Addendum No. 6, July 11th, 2025

Re: Johnson Hall Renovation – PKG 3
Johnson Hall Renovation & Foster Demolition
Tennessee Technological University
SBC Project No. 364/011-04-2022CM

2

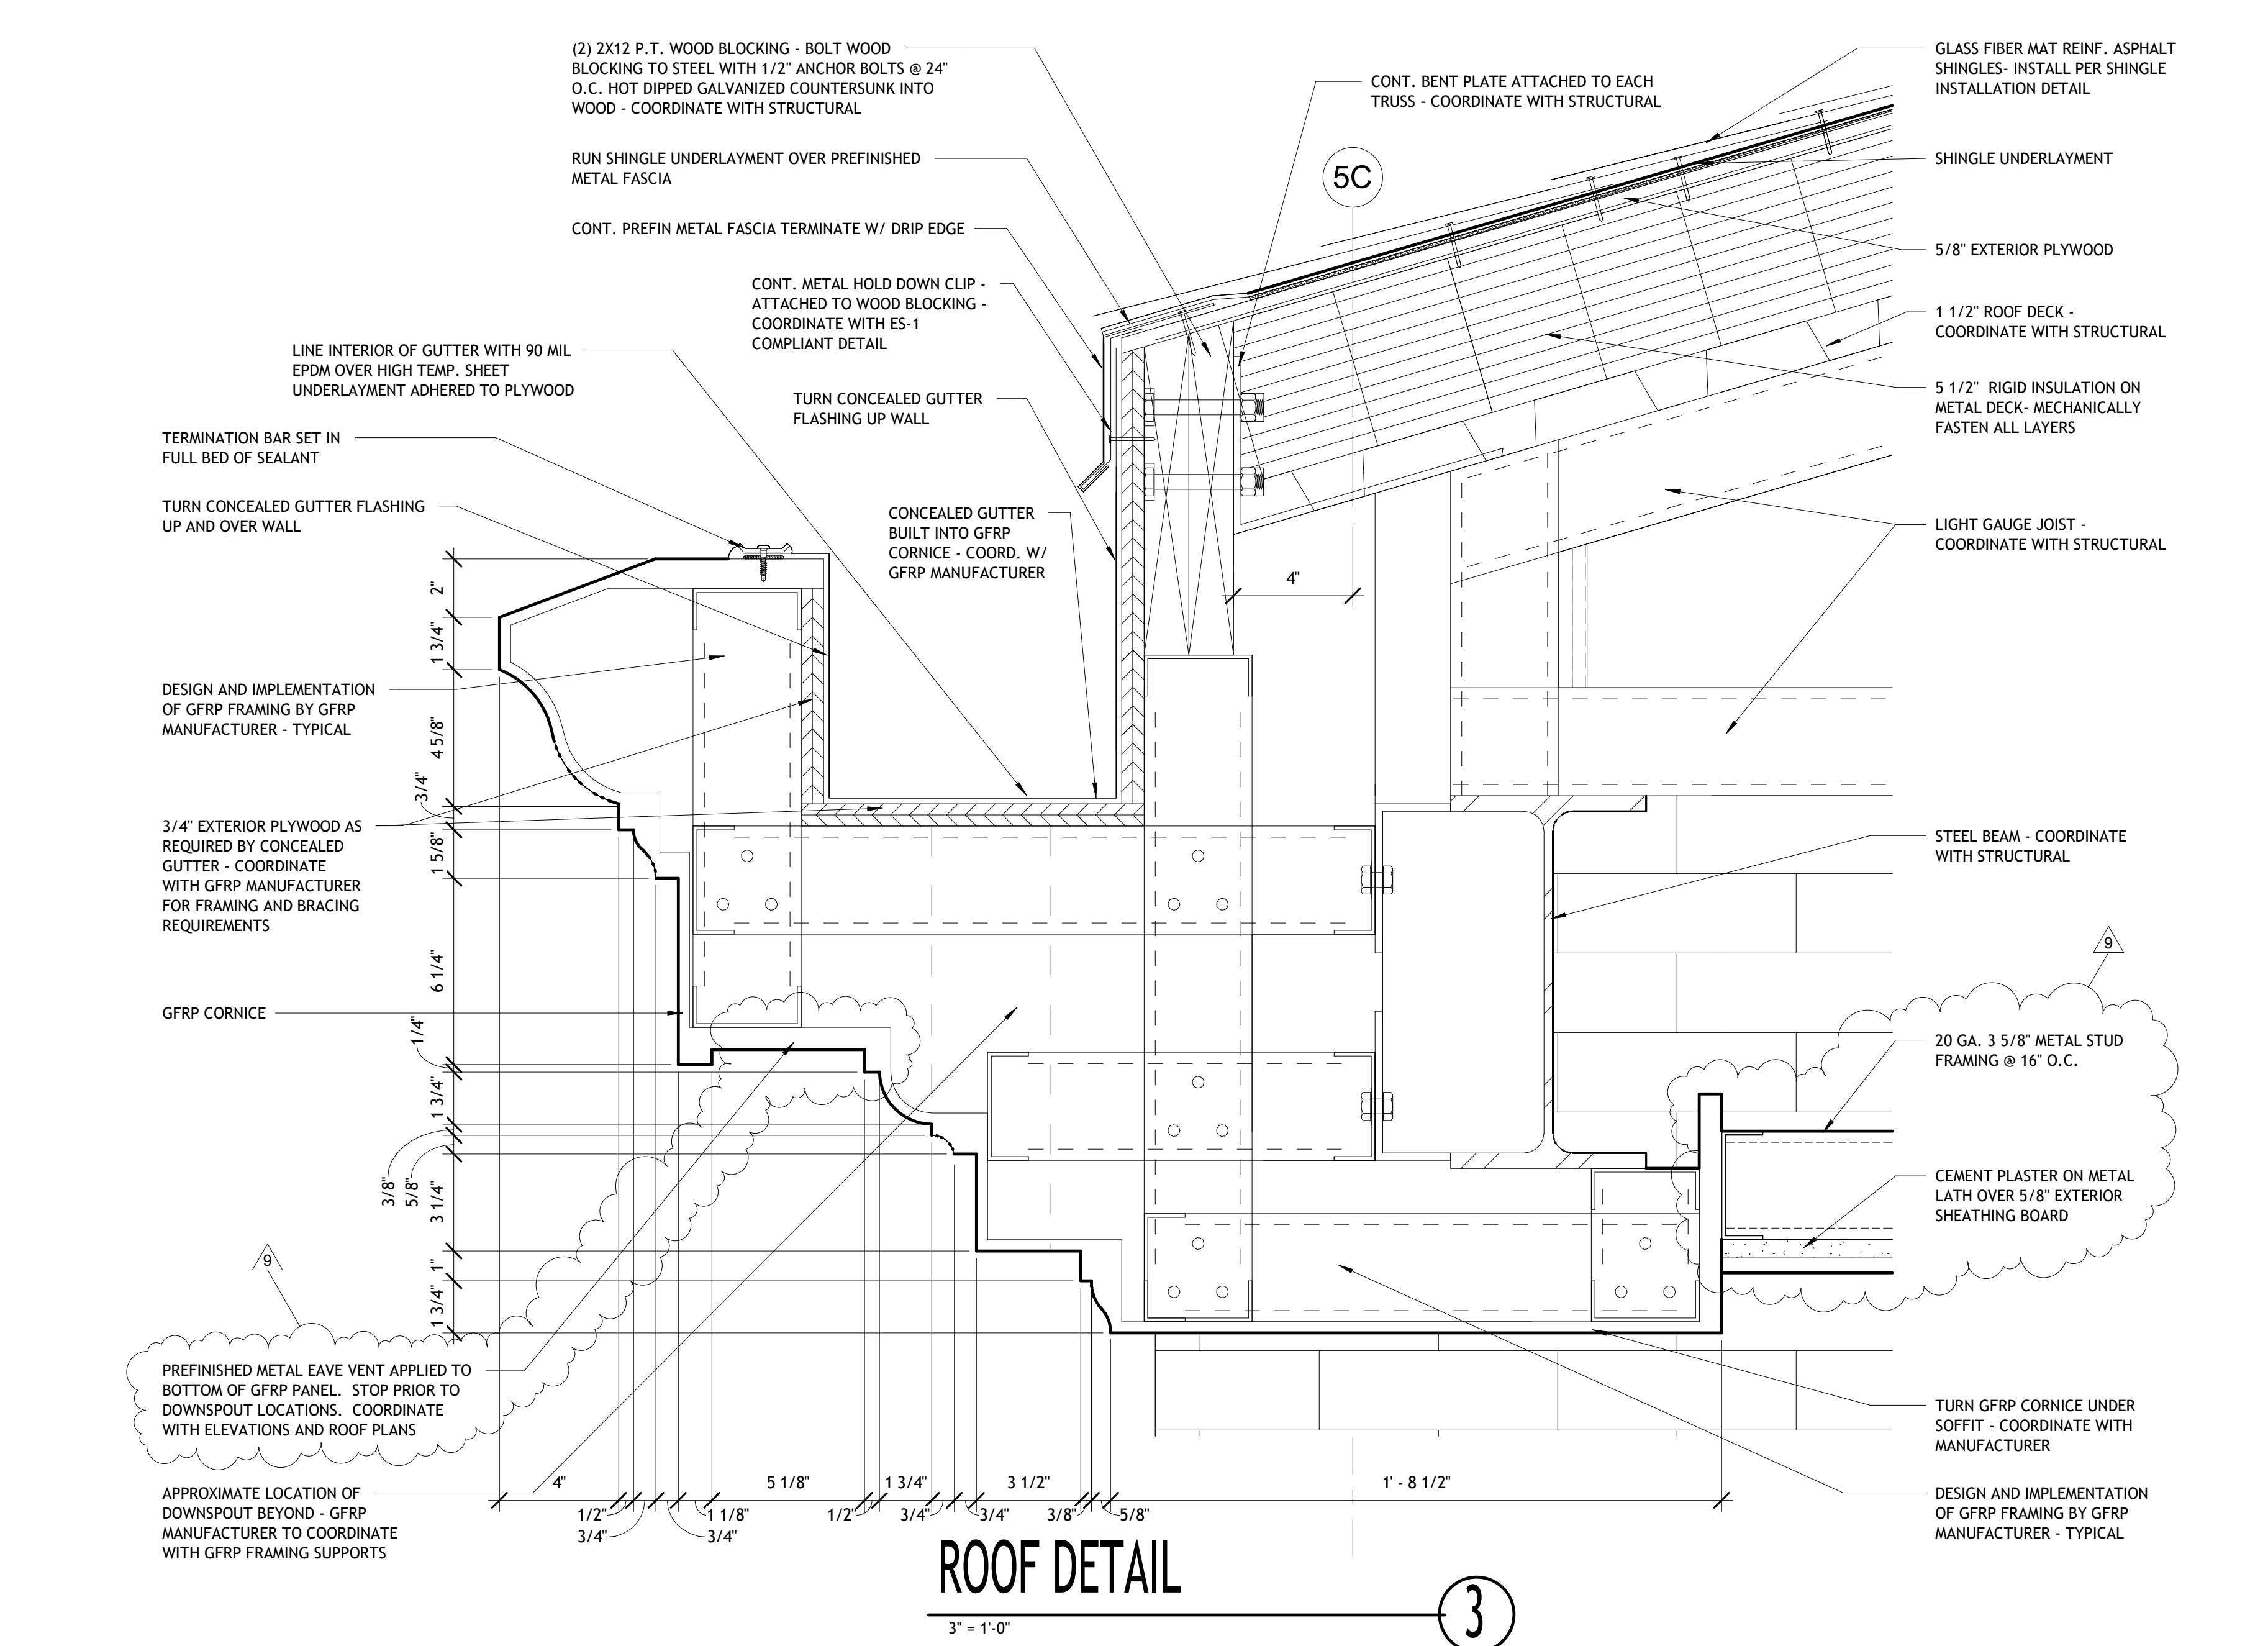
- 12) Refer to sheet A4.22 details 1 and 2. Change portico material to cement plaster on metal lath over 5/8" exterior sheathing board.
- 13) Refer to Sheets A5.12, A5.13, A5.14, and A5.15. Add prefinished metal eave vent applied to bottom of GFRP panel to locations shown on revised details.

A5.14

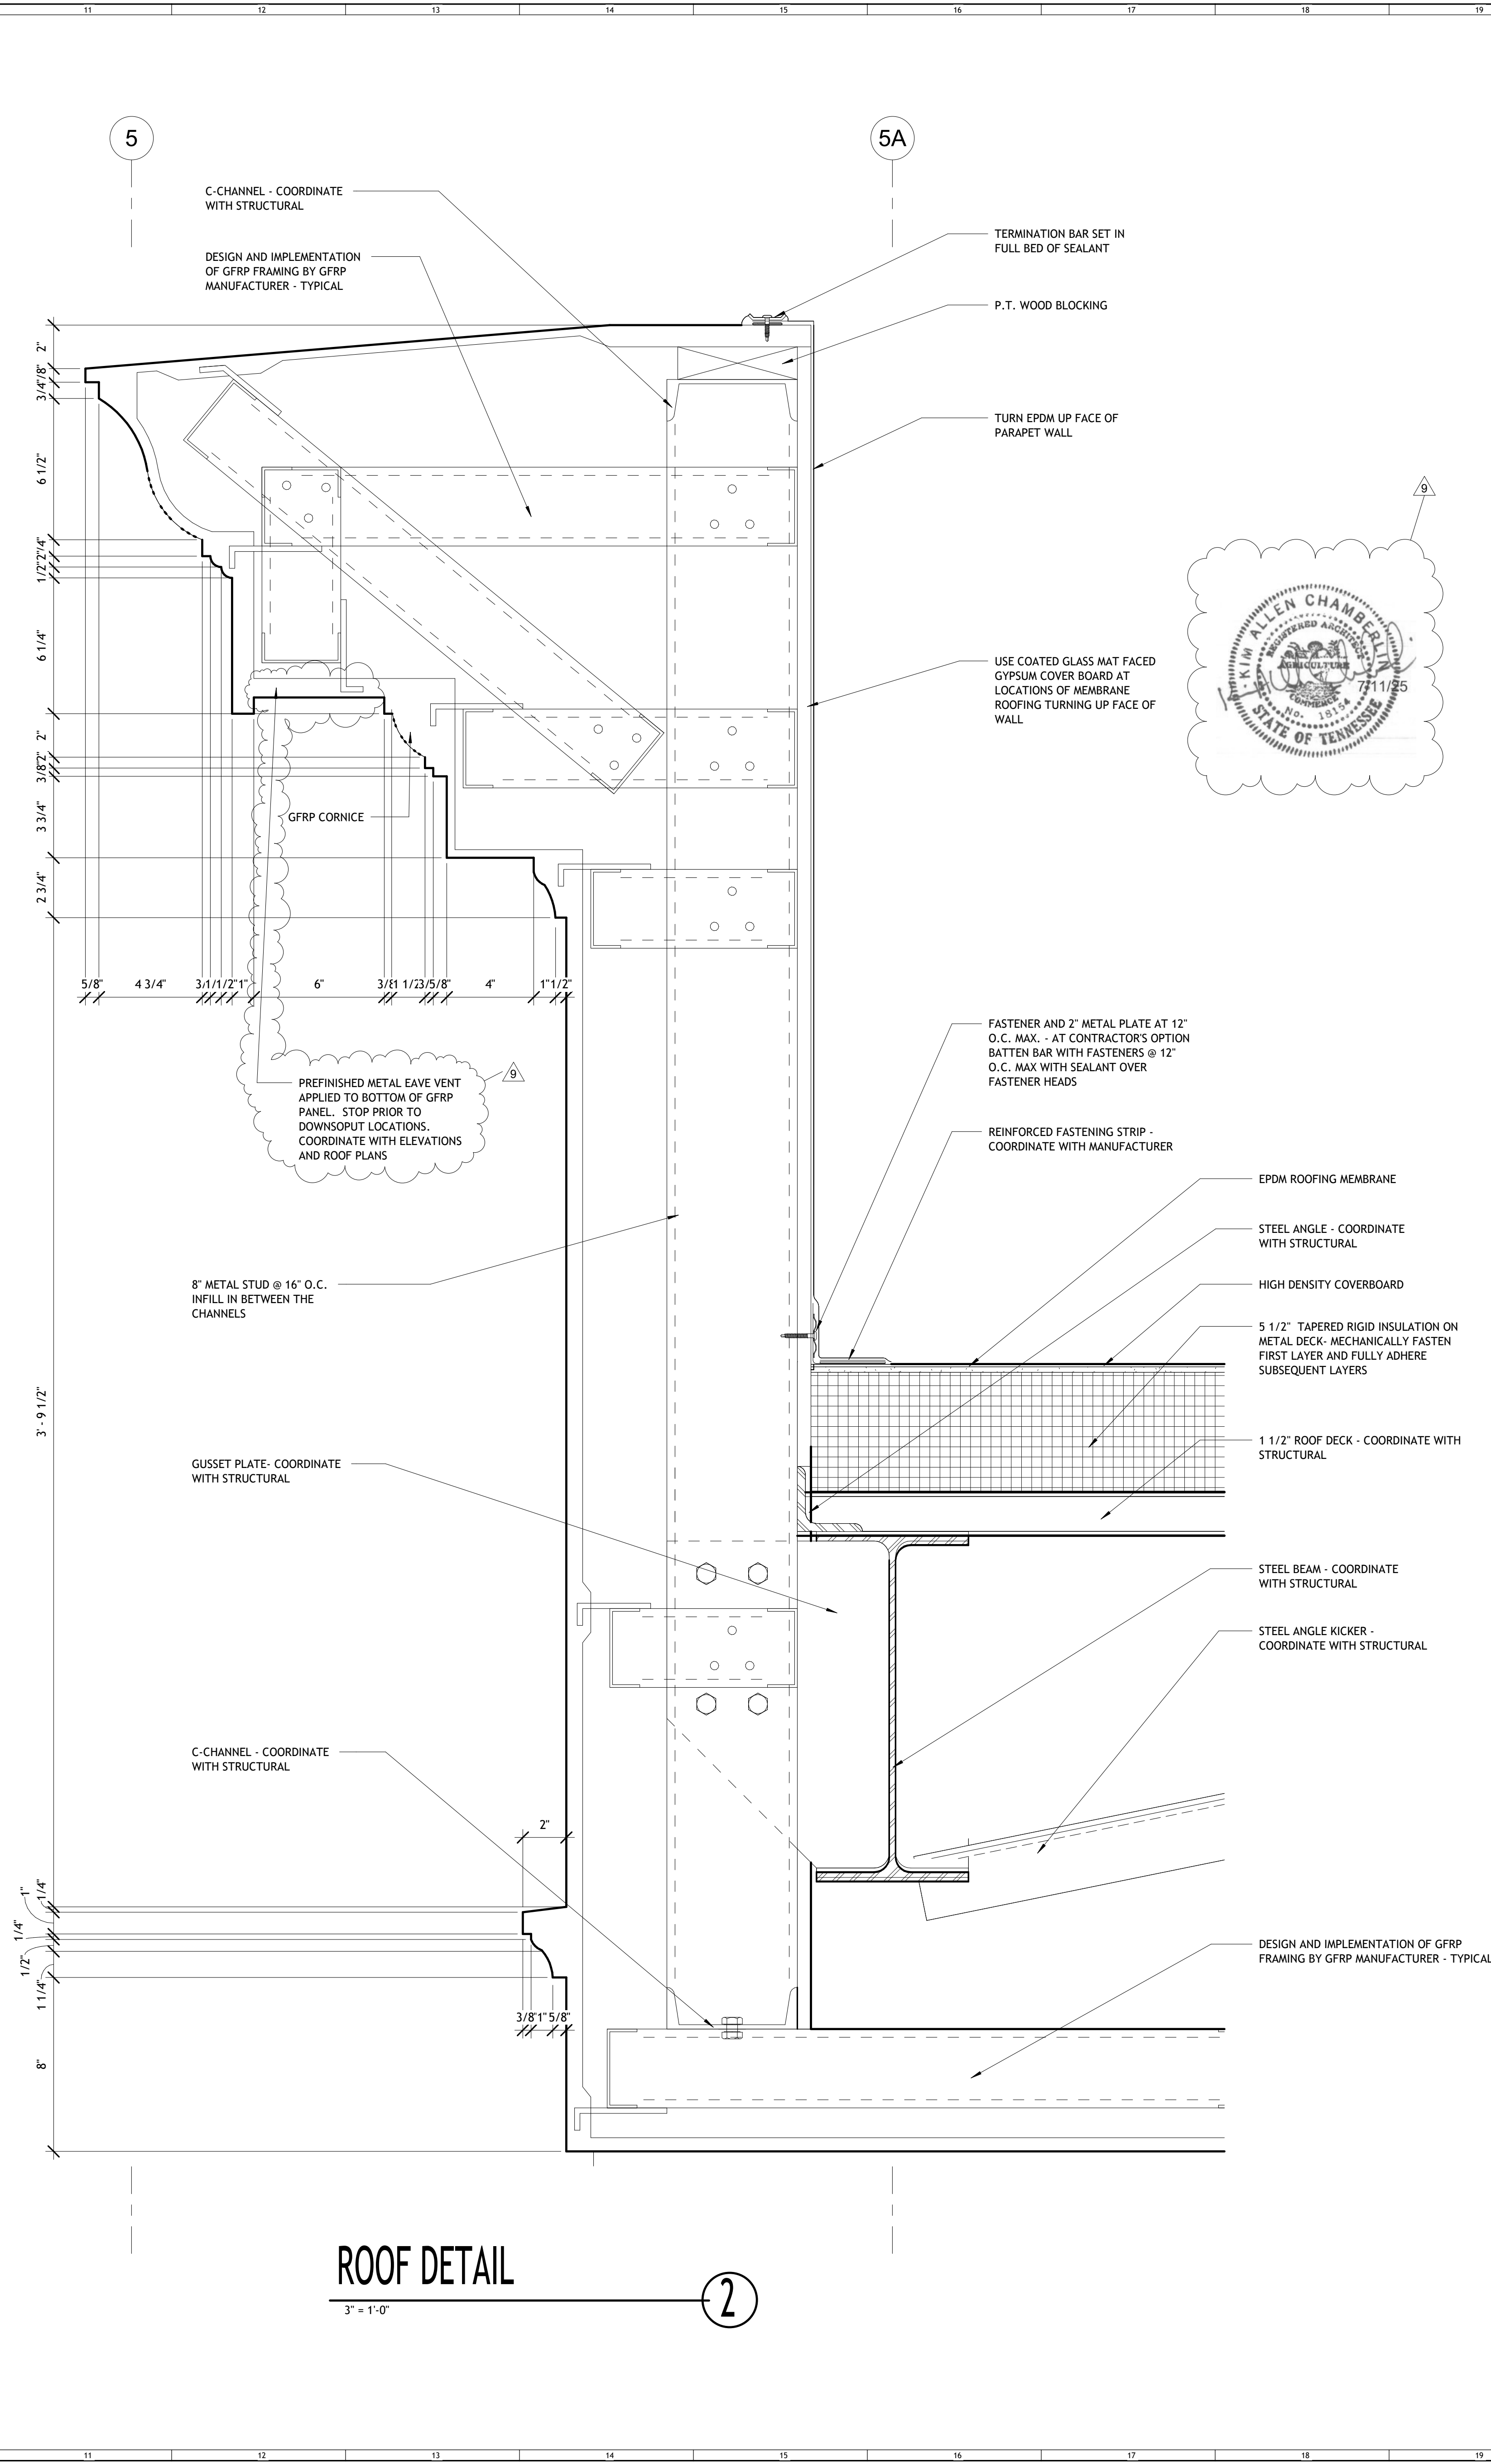
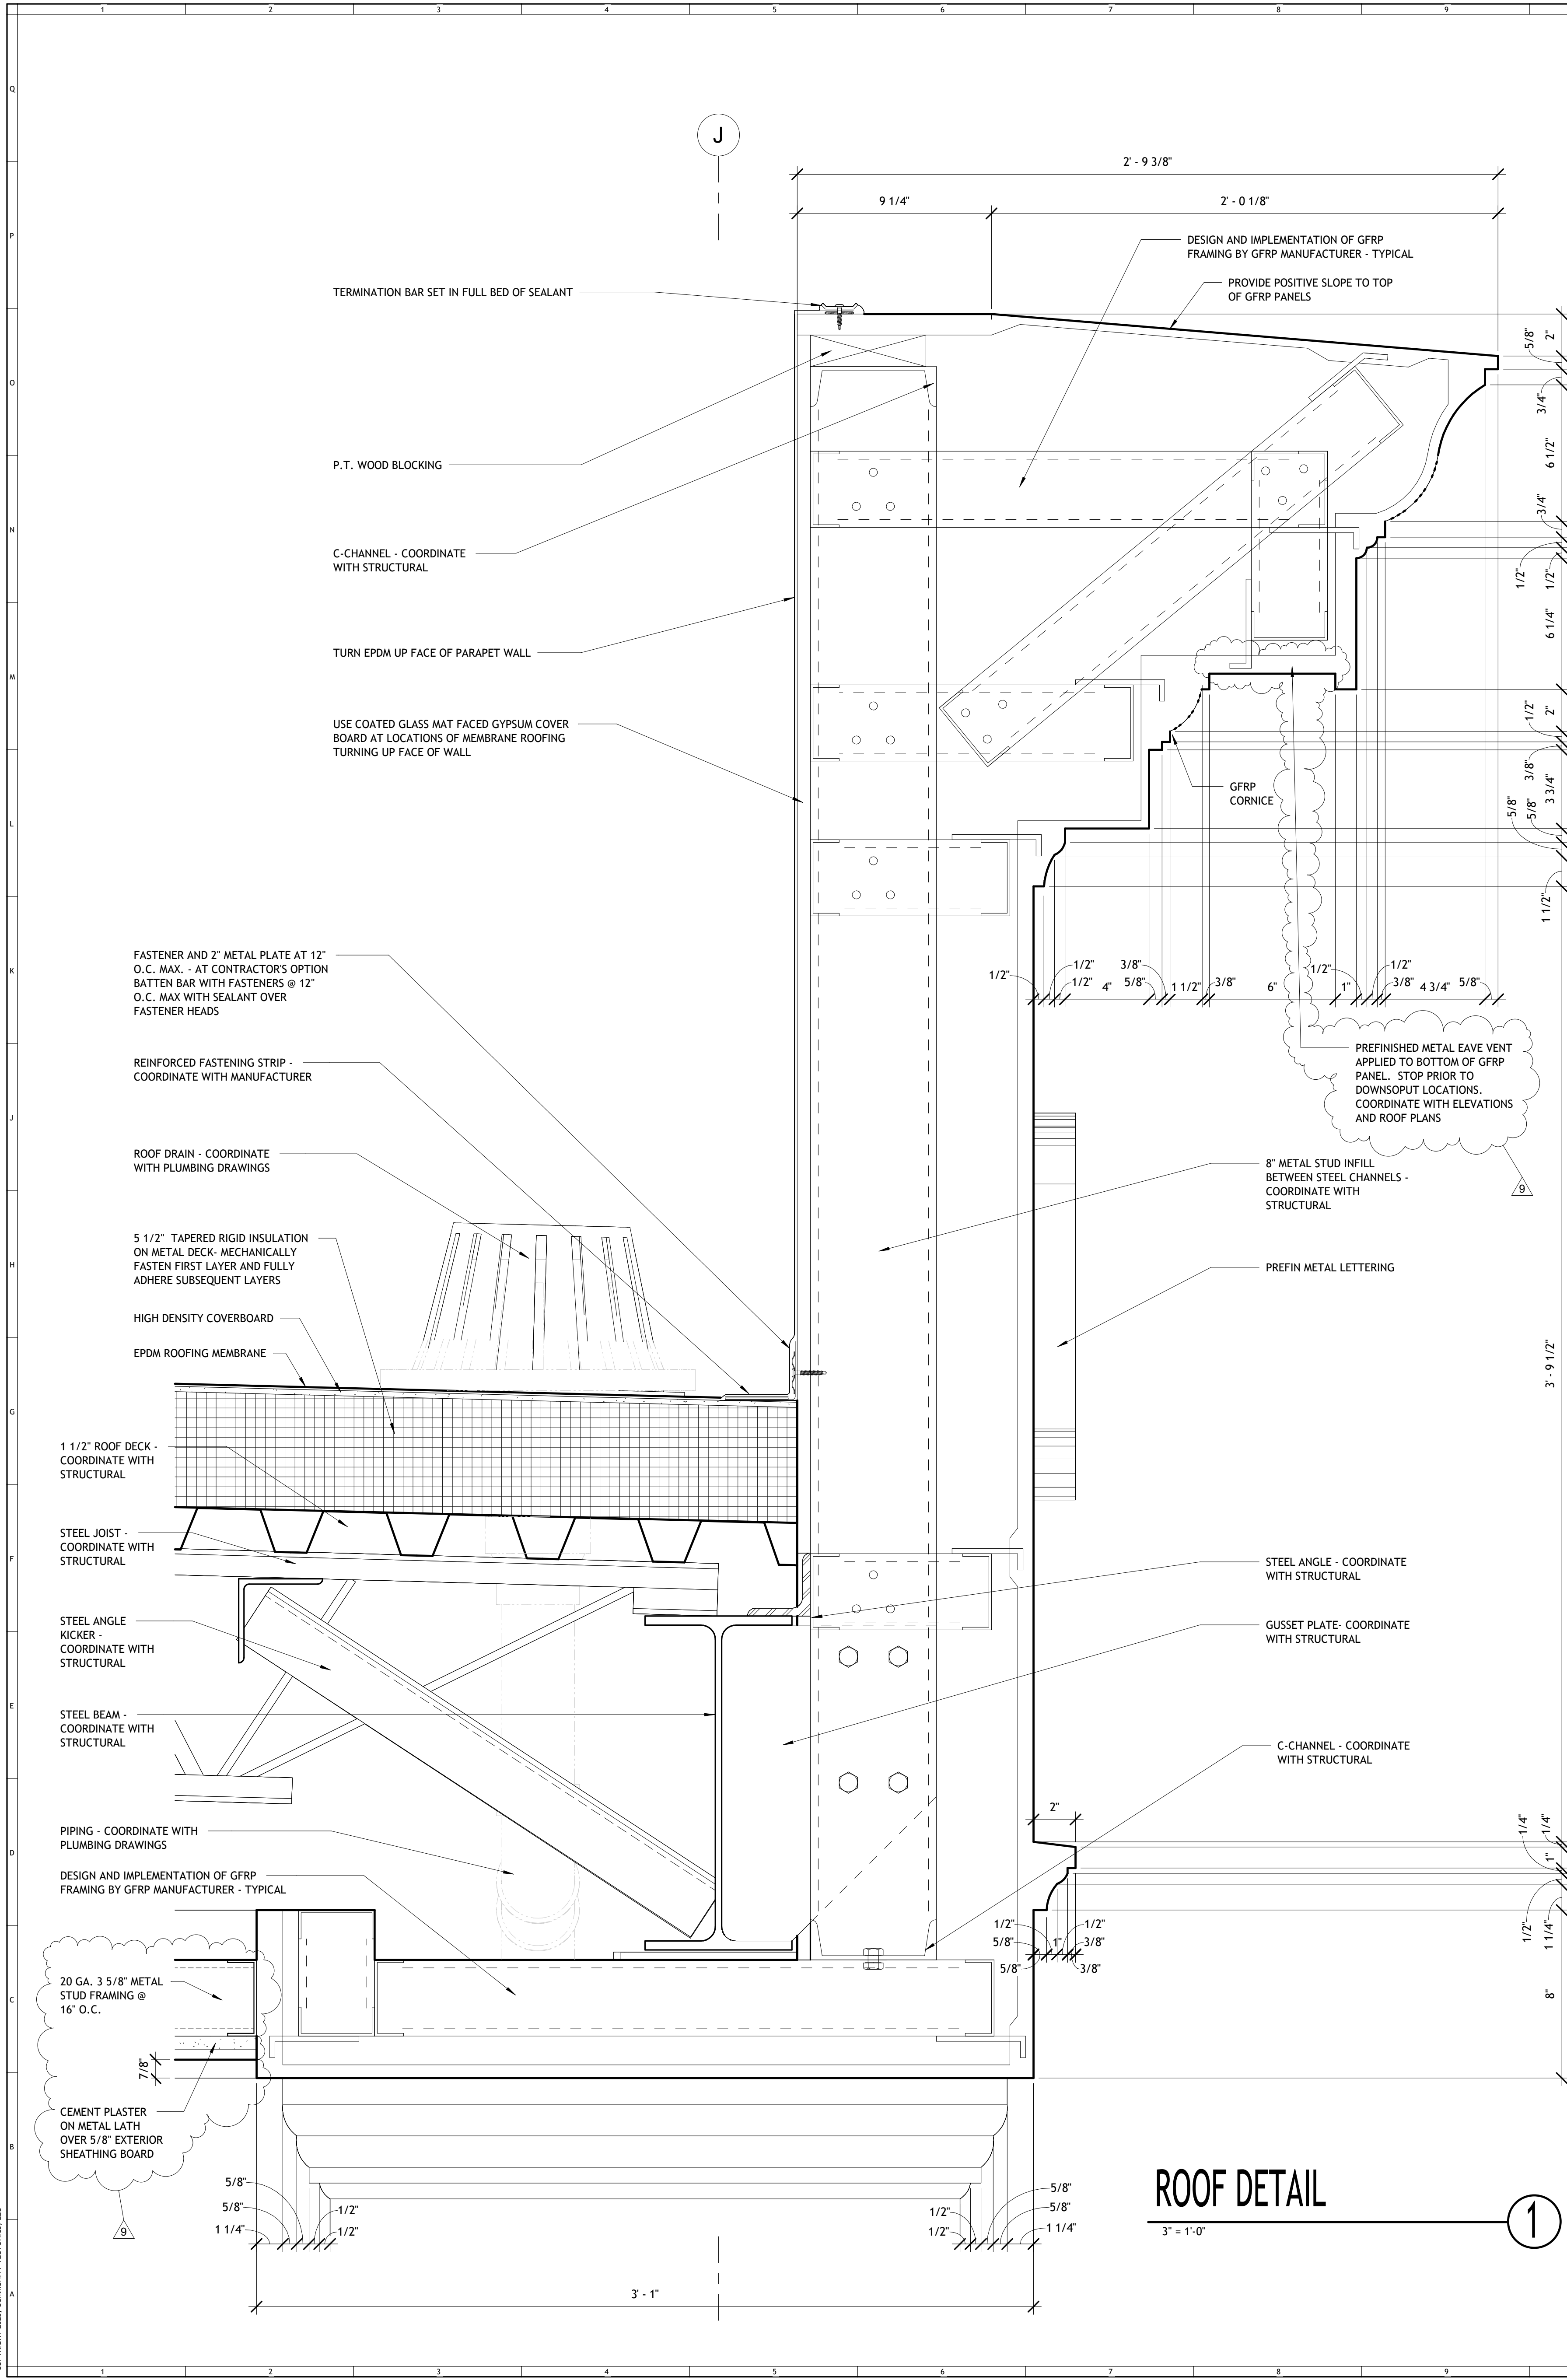
- 14) Refer to sheets A5.12, A5.14 and A5.15. Change soffit at front portico, back portico and above exterior balcony to be a cement plaster on metal lath over 5/8" exterior sheathing board on 20 GA 3 5/8" metal stud framing @ 16' o.c.
